Sherwood Planning Commission Agenda

February 10th, 2026 – 6:00 PM
2201 E. Kiehl Avenue, Sherwood, AR 72120
Blake Martin, Chairman

Application: REZ.202601.8709 Teetwood

Application Type: Site Plan Review
Application: SPL.202601.8709 Teetwood

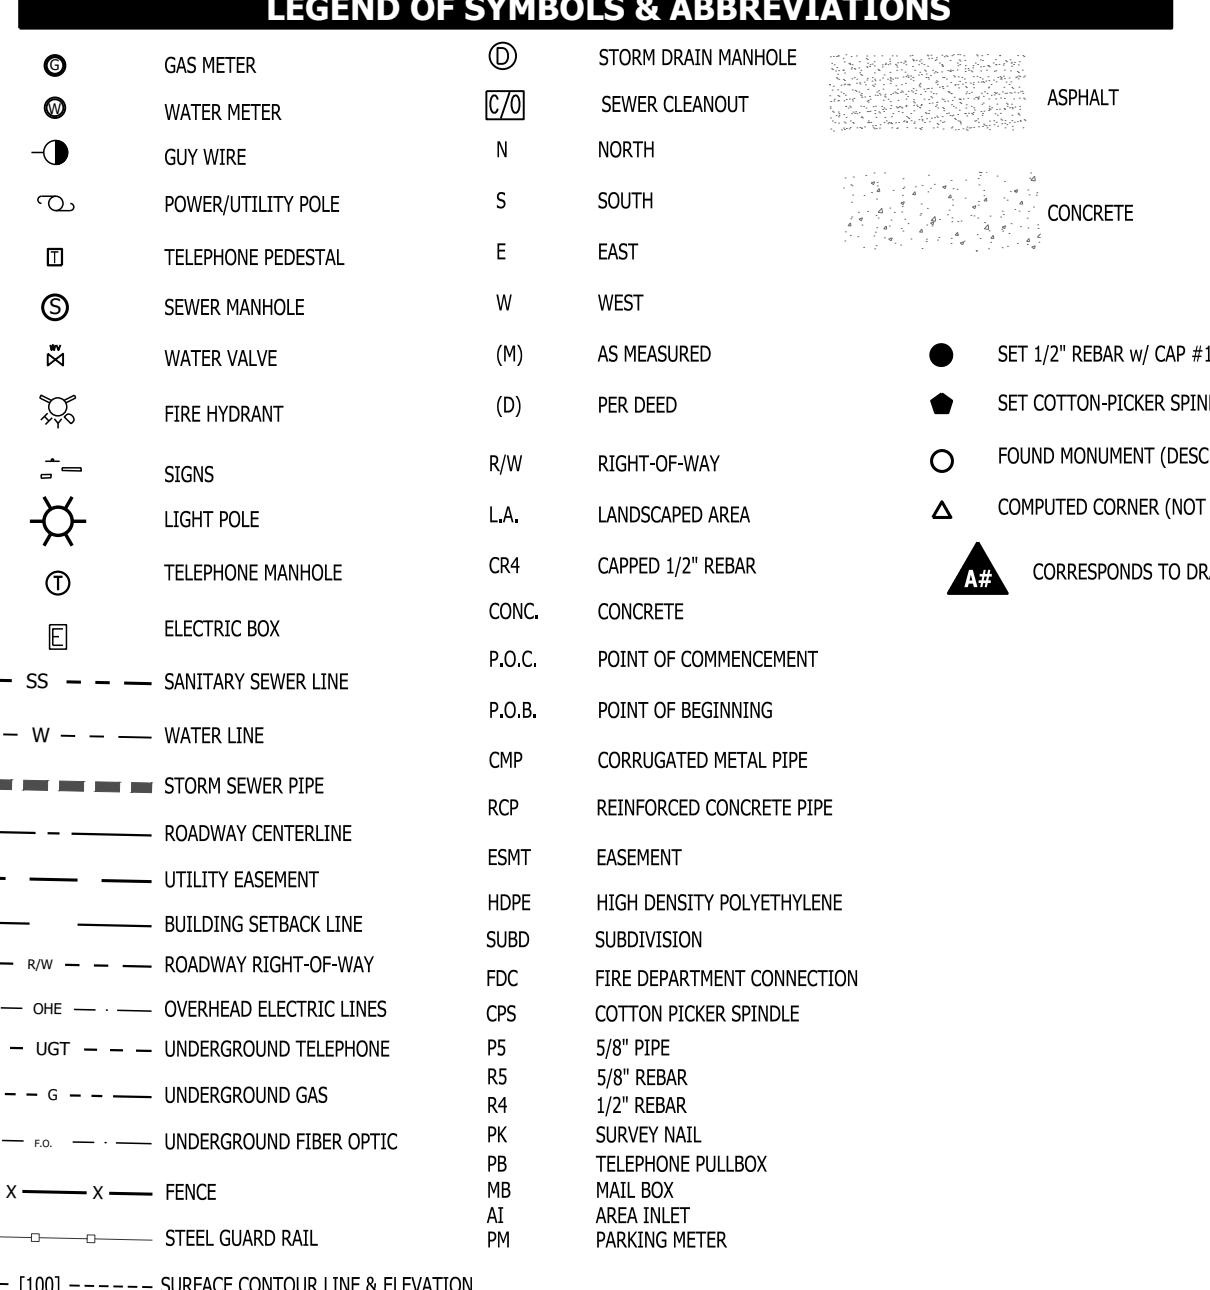
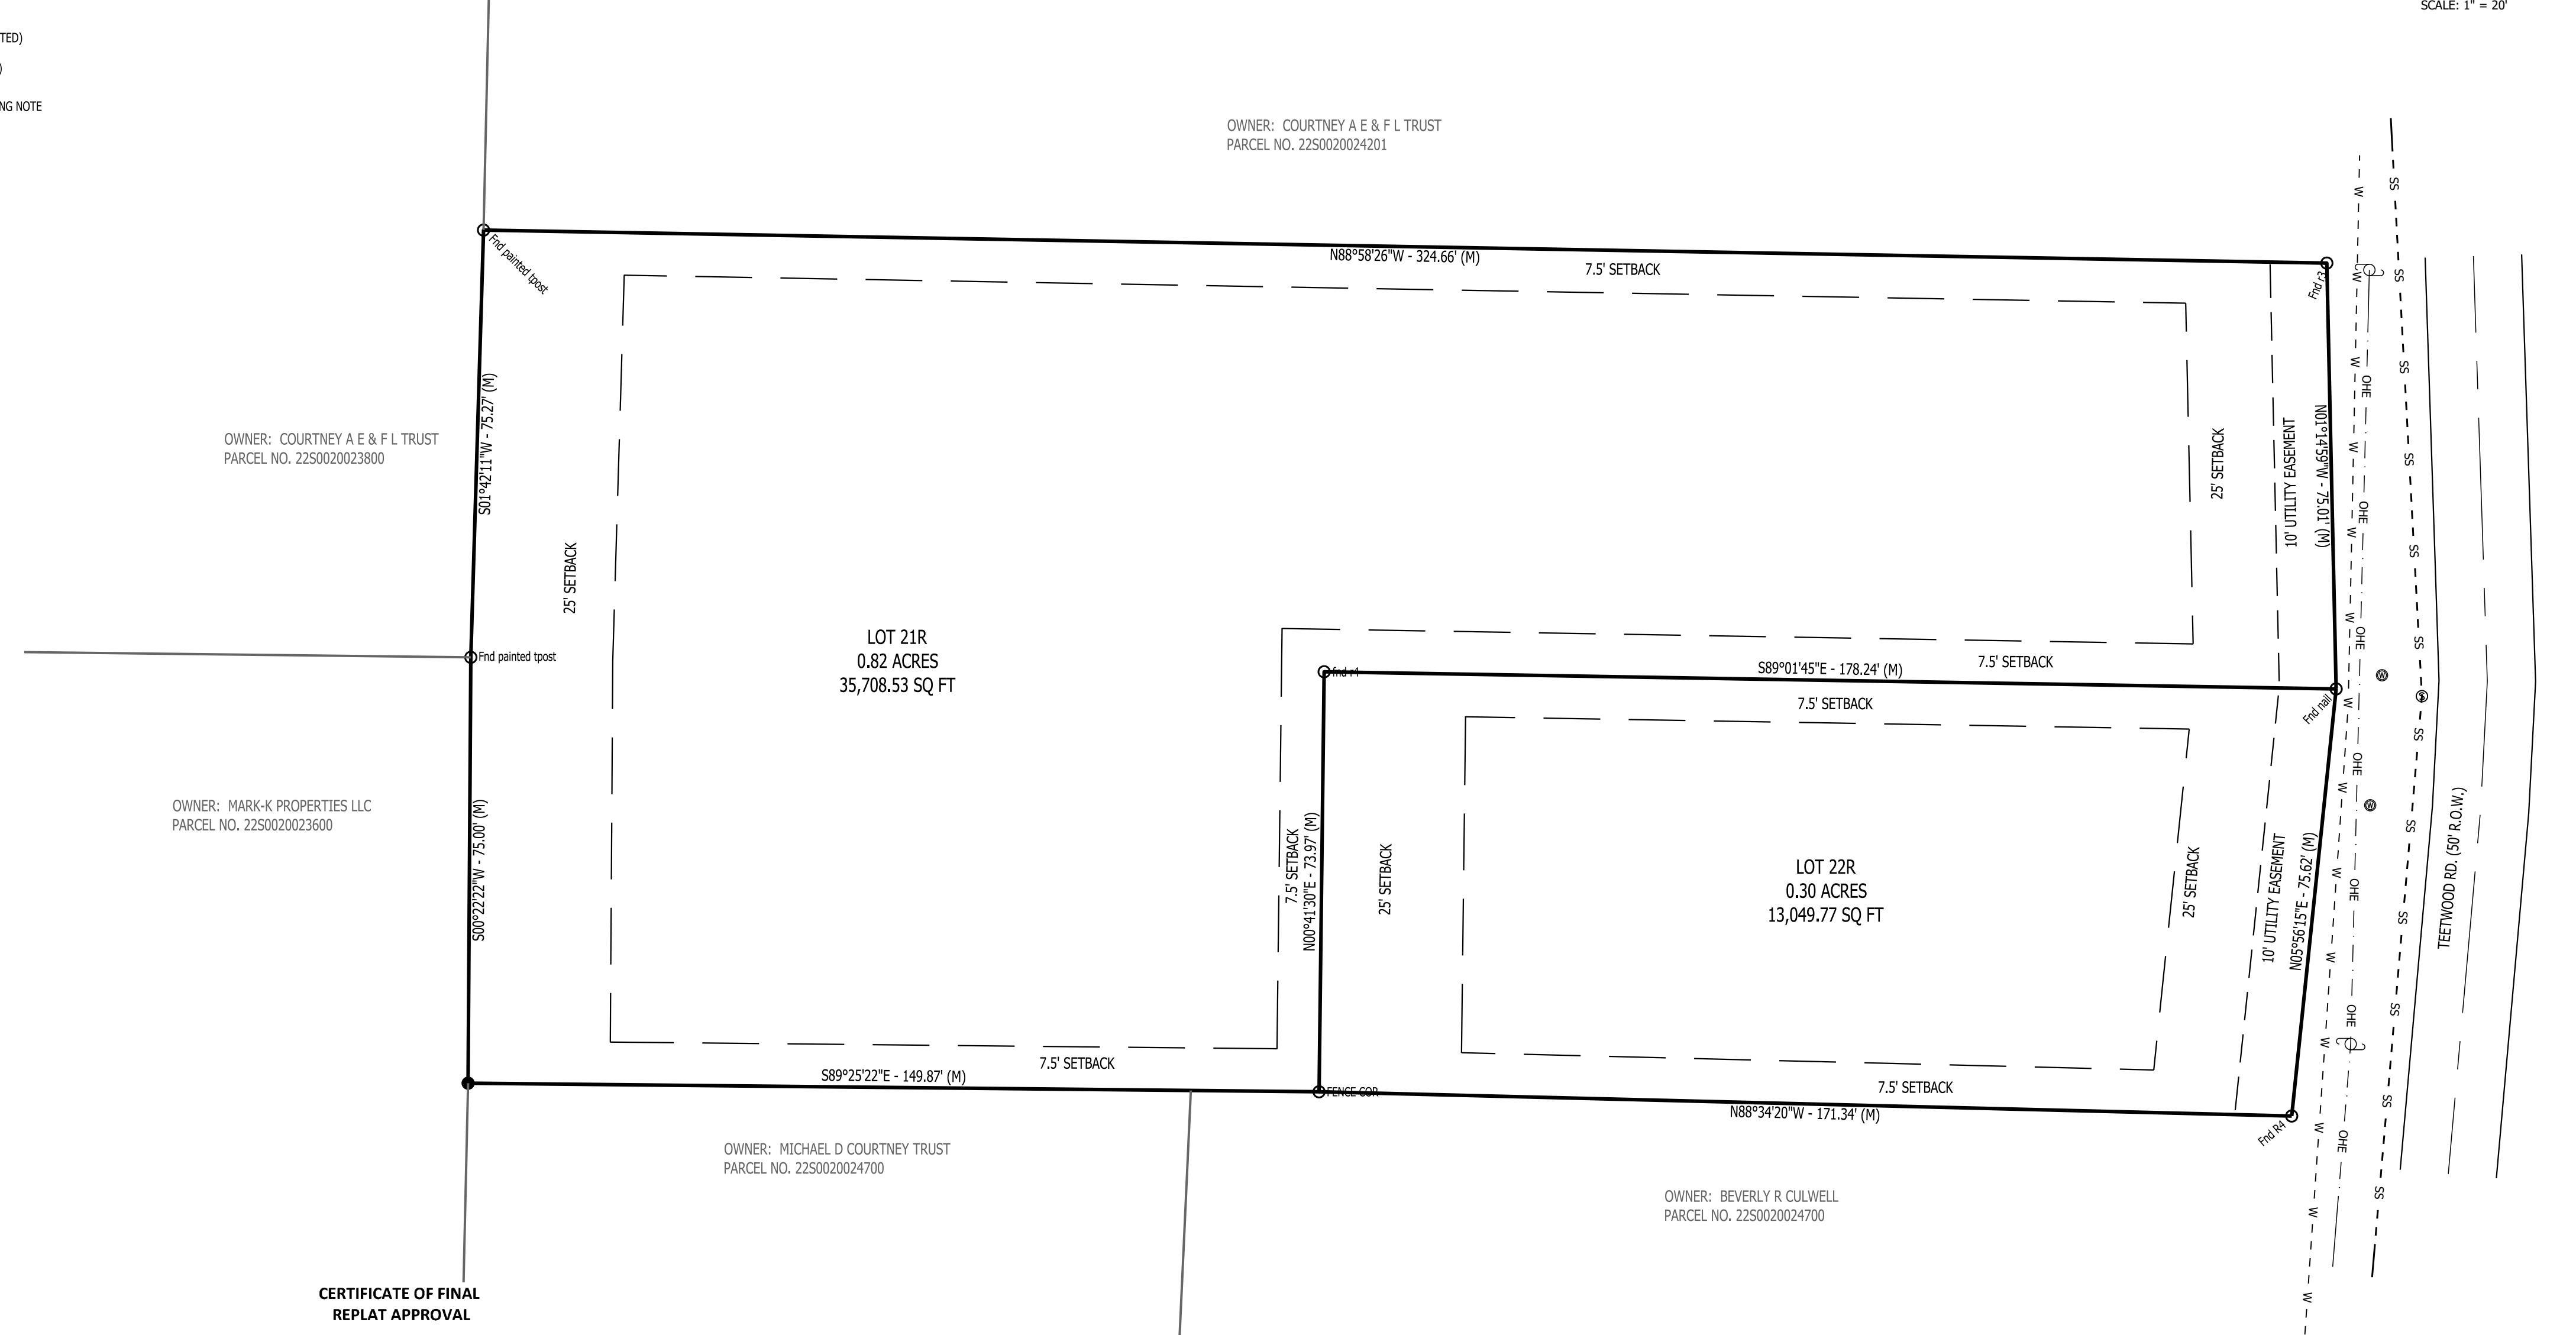
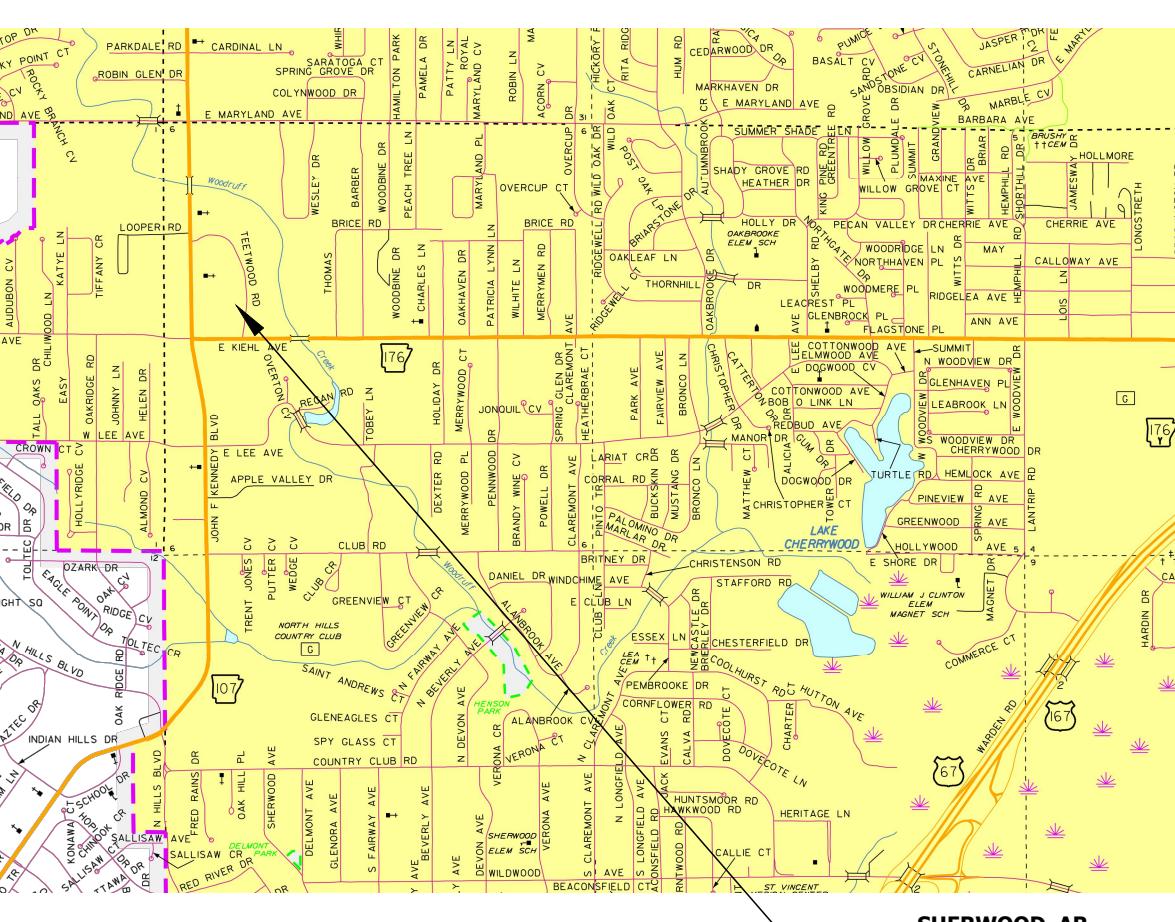
1. Scaled site plan: **Site plan review of 1 proposed lot containing 1 duplex structure – yielding 2 dwelling units.**
 - a. Graphic scale: **Addressed; site plan indicates a Scale 1" = 10'.**

- i. **Applicant proposes two (2) driveways to serve each individual dwelling unit.**
 - ii. **Revise plan to indicate required sidewalk improvement and green space on the west side of Teetwood Rd in accordance with the Public Works Residential Standard Detail. Staff would entertain consideration of modified street improvements, with approval of the consulting City Engineer, considering the current built condition of Teetwood Rd as open ditch and no sidewalks. Addressed; applicant request a waiver to the required sidewalk improvement on the basis of existing roadway conditions and Teetwood Rd developed condition of single family dwellings.**

- d. Proposed perimeter treatment of the property, indicating screening materials to be used including fences, walls, and plant materials together with a description of uses, setbacks and their proposed relationship to surrounding areas. **Partially addressed; applicant proposes addition of 6' opaque wooden privacy fencing along the west, north and south property boundary. Applicant must revise site plan to detail termination of the 6' fence at the 25' front yard setback or indicate tapered fencing in accordance with §14.10.02.B.1.b. of the Zoning Code.**

- iii. *Provide existing and/or proposed opaque fence material and capture elevation on site plan. Addressed; revise linework to depict fencing in the legend matches the proposed 6' opaque privacy fence indicated on the site plan.*

- f. Location and dimension of all existing and proposed utilities, drainage, and street easements within the site. *Not addressed; indicate all existing and all proposed utilities on the subject property and provide use. Capture linework in legend. Addressed; applicant indicates location of existing utilities adjacent to Teetwood Rd.*

- a. Proposed building coverage of principal and accessory buildings. *Not addressed; applicant must calculate and provide a General Note indicating the proposed building coverage of all principal and all accessory structures [% format required].*

- d. Proposed number of parking spaces. *Action required; applicant proposes two standard 12' driveways to serve each unit allowing adequate parking spaces at 1 ½ spaces per dwelling. Applicant must provide a General Note to address the number of parking spaces provided.*

- c. *Adequate street frontage must be provided for the entirety of Lot 22 upon replat into two (2) legal lots of record. The current site design indicates extensive lot coverage, which may preclude the ability to provide the minimum required 20' street frontage necessary for the rear portion of Lot 22.*

1. Revise the site plan to indicate removal of the proposed 6' opaque wood privacy fence at the 25' front building line, or provide tapered fencing in accordance with §14.10.02.B.1.b.

2. Provide a General Note stating that proposed plant material adjacent to R-1 zoning (west, north and south property boundary) will achieve a minimum height of 8 feet and a minimum width of 5 feet within five (5) years.

5. Planning Commission approval to waive the required sidewalk improvements along Teetwood Road; or revise plan to indicate installation of required improvements.

SITE PLAN REVIEW
 LOTS 1 & 11, BLOCK 2
 CARROLL HEIGHTS SUBDIVISION
 CITY OF SHERWOOD,
 PULASKI COUNTY, ARKANSAS

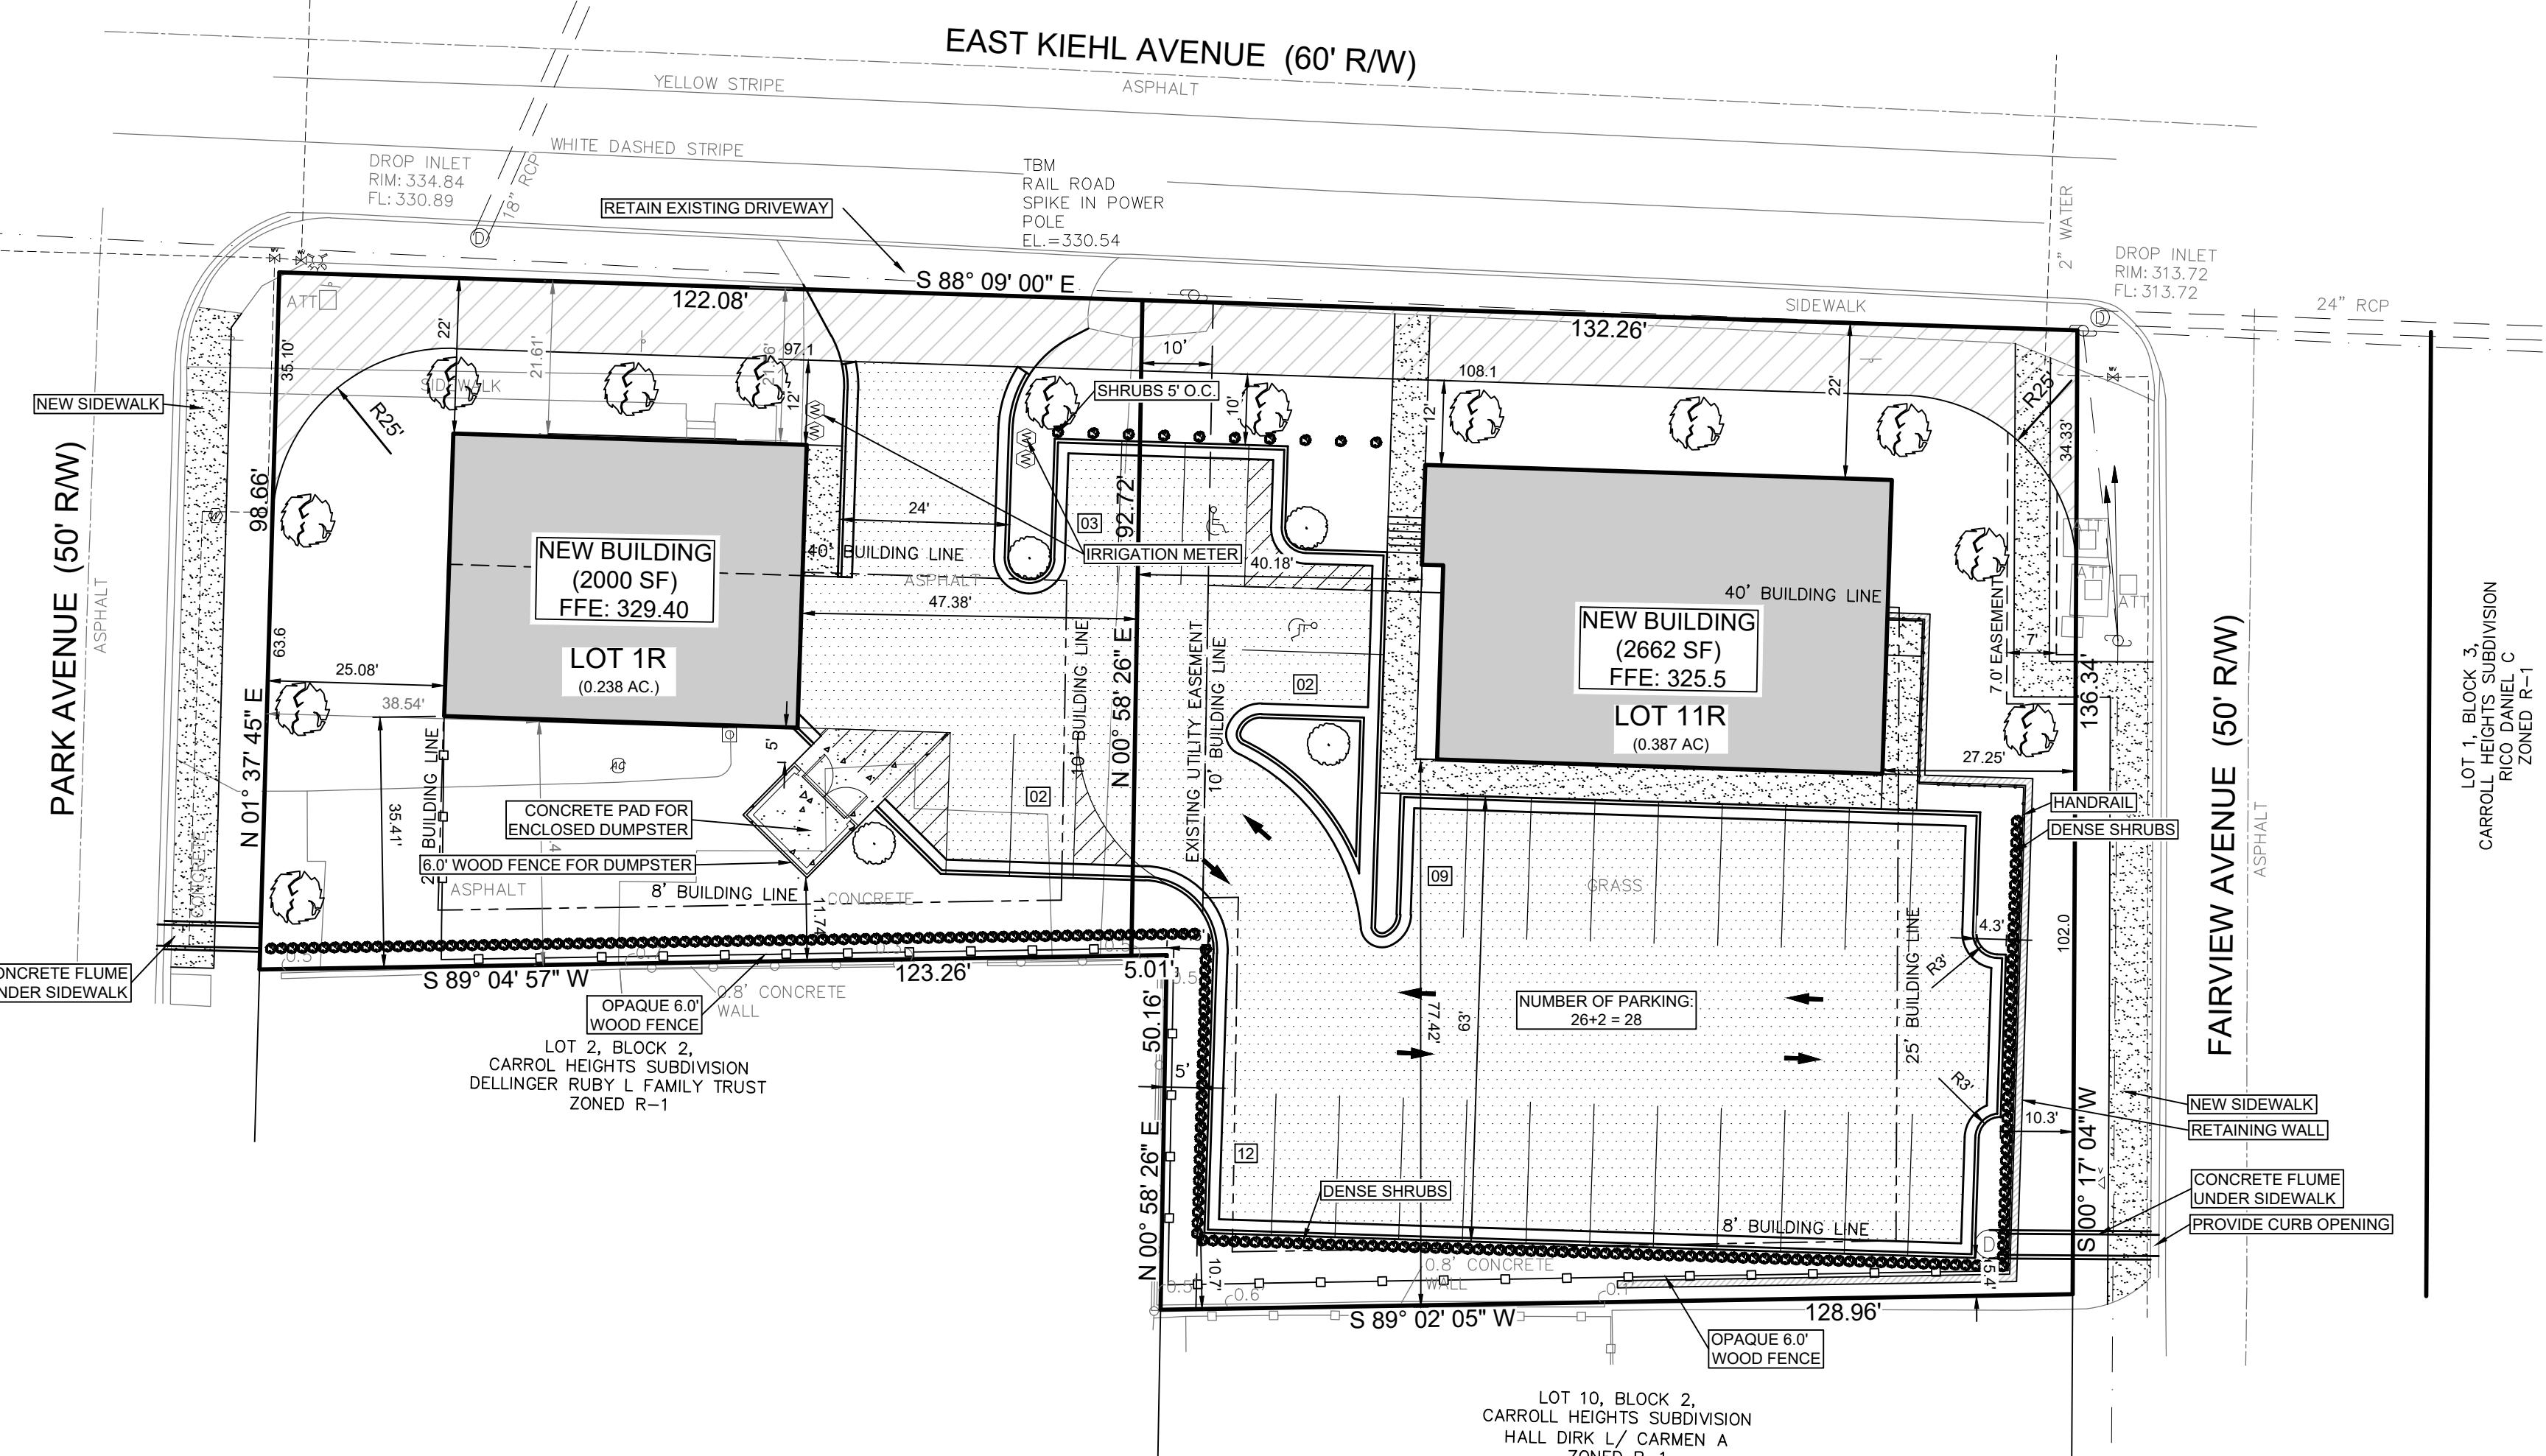
- iii. *An approved fire apparatus turnaround or secondary point of ingress/egress is not provided. Adequate turnaround must be provided in accordance with AFPC Appendix D Section 103.4. Not addressed; applicant must indicate fire apparatus turnaround on the site plan [see #5.g.].*

- iv. *Revise site plan to capture required sidewalk improvement on Park Ave, ensuring each individual sidewalk improvement along Park Ave and Fairview Ave meets minimum 5' sidewalk required.*

1. *Will the power pole and AT&T box on Fairview Ave need to be relocated to accommodate the new sidewalk? Addressed; additional action required. Applicant relocated Fairview Ave sidewalk improvement to mitigate conflict with existing utility. Relocation of the sidewalk improvement within bounds of Lot 11R [private property] must be captured in an easement. #CAPTURED IN REVISED PLAN*

2. *Replat approved November 10, 2025 must be revised capture sidewalk easement on Lot 11R if desired location is retained for the required improvement. #EASEMENT WILL BE SHOWN IN THE FINAL PLAT*

- v. *Revise site plan to indicate a stub out turnaround in the main parking area to allow vehicles parking in the easternmost parking spaces to backout. Captured on site plan; applicant must dimension stub out turnaround. #DIMENSIONS ARE SHOWN FOR STURBOUT TURNAROUND.*

- i. *Indicate building setbacks for C-2 zoning district on both lots to all property lines. Addressed*
 1. *Applicant has submitted a variance request to reduce the front yard setback across Lot 1R and Lot 11R concurrently with site plan review. Site plan as submitted indicates the reduced front yard setback on Lot 1R and Lot 11R, as requested.*

1. *Indicate existing driveway south of Lot 1R (serving residence at 8218 Park Ave) on site plan to determine no deviation from site triangle requirements is created by the proposed 6' opaque fence*
